**PROJECT**  
**Florida Rock Planned Unit Development**  
Modification (Square 7080)  
100 Potomac Avenue, SE  
Washington, DC

**NCPC FILE NUMBER**  
ZC 14-04B

**ACTION TAKEN**  
Approve with comments

## Executive Director's Recommendation

Figure 3: Illustrative Site Plan

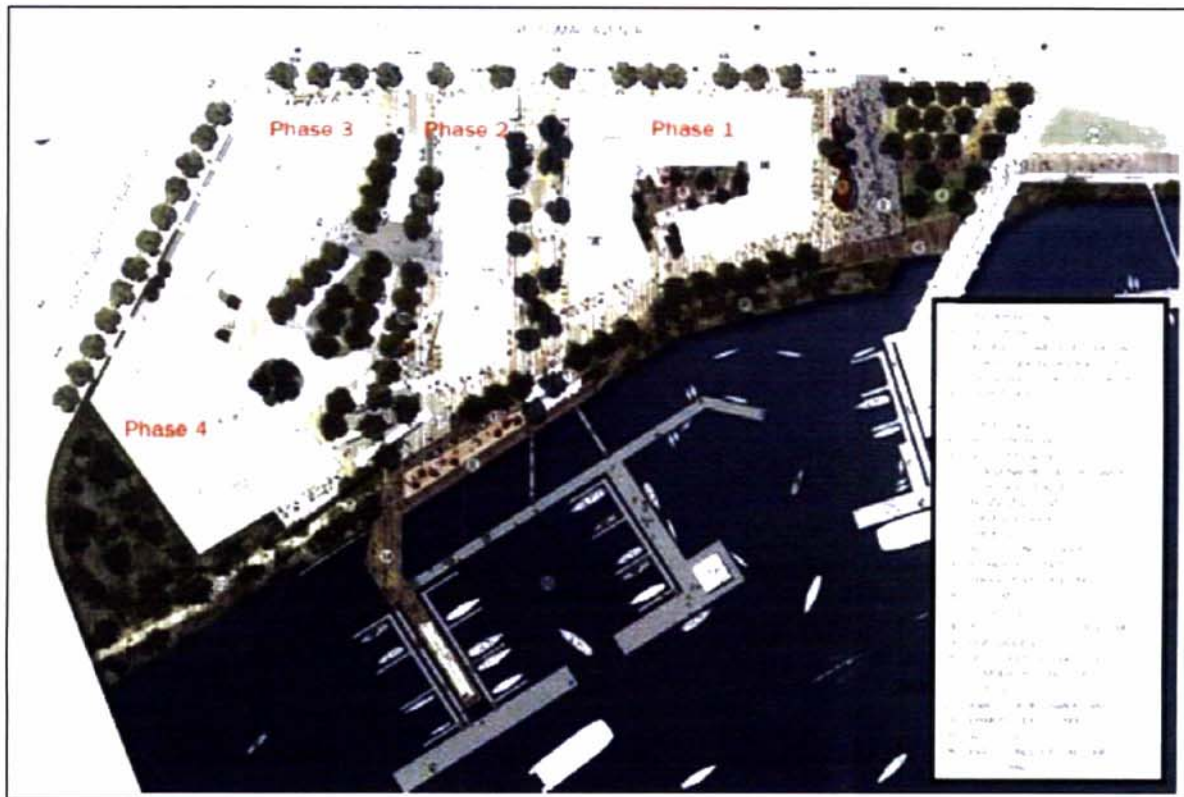
The proposed Florida Rock PUD application modification appears to improve the existing design through the addition of additional residential units; an open space network that better relates to the Diamond Teague and the Yards Parks; and improved urban streetwall along Potomac Avenue. In addition, the modified design will preserve important views between the Washington Nationals Ballpark and Anacostia River; provide multiple pedestrian/bicycle connections between the City/Near Southeast and Anacostia River; and minimize the development's potential water quality impact on the Anacostia River through its use of a bio-filter garden along the riverfront (shown in the following figure).

Figure 10: Modified Florida Rock PUD Pedestrian Circulation

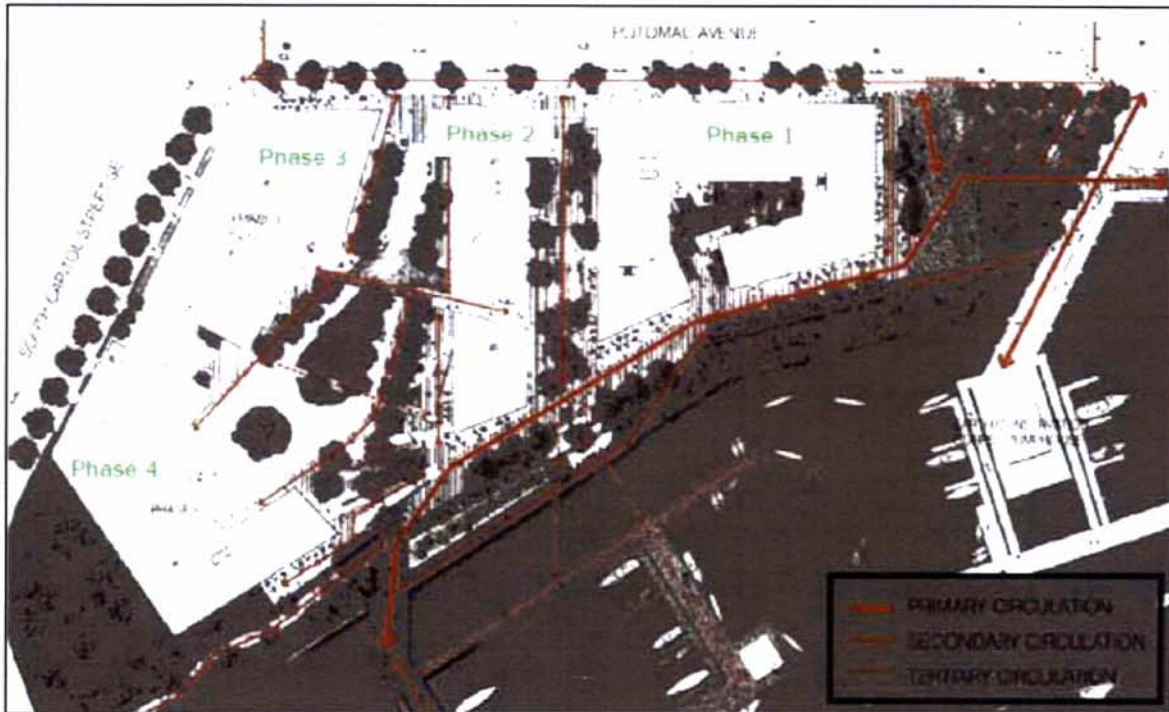
The Plan also recognizes current on-going planning efforts to redevelop South Capitol Street as a vibrant urban boulevard and waterfront “gateway” at the Anacostia River. Staff notes that the proposed modified Florida Rock PUD design supports this concept by providing a mix of uses (retail, residential, office, and hotel) and multiple visual, pedestrian, and bicycle connections

between the buildings to help link the City with the Anacostia riverfront. Figure 10 shows these connections through the future PUD.

It will be important to ensure that the more detailed Second-Stage designs for the Phase 3 and 4 buildings are appropriate for the future iconic image of South Capitol Street as a gateway into the City and as a “vibrant urban boulevard”. In addition, the Phase 4 building’s positioning directly adjacent to the future potential commemoration Site # 38 makes it essential that the future design does not somehow diminish the site’s viability as a future memorial site.

**Recommends** that the future Phase 3 and Phase 4 building designs befit the future planned South Capitol Street as a significant gateway connection into the City and vibrant urban boulevard as identified by the Monumental Core Framework Plan, and the overall development design should preserve Site # 38 as a future potential commemoration site.
